Central Sense Bulletins

Central Sense

Amana HAC Technical Services

New Propane Low Pressure Kit (LPLP01)

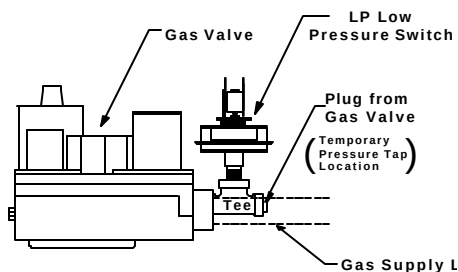
Throughout the heating industry we have seen 80% and 90% furnaces soot up due to various reasons, one of which is due to propane levels in the storage tank dropping to low causing insufficient gas pressure for the burners to operate properly which in turn causes sooting in the heat exchanger. A new accessory has been slated to be released by this fall by Amana for use on our gas furnaces when converted to propane gas use. This new kit is known as the LPLP01 and should be used with all propane gas furnaces installations. The new LPLP01 kit consists of the following:

The following drawing illustrates the LPLP01 in a typical installation.

The LPLP01 will monitor the gas line pressure and will disable the units' gas valve if the line pressure drops below acceptable levels. This kit provides control over the unit gas valve by routing the gas valve wiring through the supplied pressure switch. To enable proper fit-up, the pressure switch kit must be installed before connecting the gas supply line to the gas valve. For new unit installations, the kit hardware may be fitted to the gas valve while the gas manifold is removed for LP gas orifice conversion. For existing installations, the gas valve line must be disconnected from the gas valve to allow fitting of kit hardware.

New and Improved Integrated Ignition Controls for 40" 80% GUIC, GCIC and GUID Furnaces

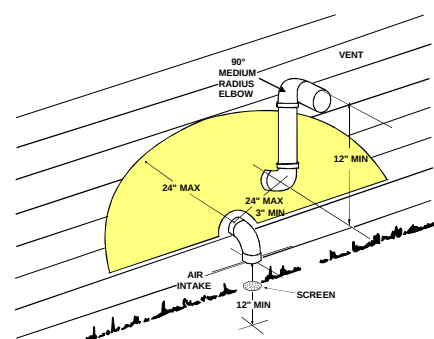
Amana is in the process of changing Ignition Controls from the White-Rodgers 50A50, Amana Part # 10207710 to the White-Rodgers 50A55, Amana Part # 10207709 for current GUIC, GCIC and GUID furnaces. This change in production will take effect by the end of April 1999.

The 50A55 ignition control is also used on the new 40" 90% GUCA and GCCA model furnaces. The White-Rodgers 50A55 ignition control has an adaptive timing that adjusts the duration of the ignitor warm-up, to extend ignitor life. Upon initial application of power, the warm-up time is 17 seconds. The ignitor on-time will then be adjusted depending on whether or not flame is achieved. The new ignition control, Amana part # 10207709, has been subbed in service parts and can be ordered as a replacement if needed.
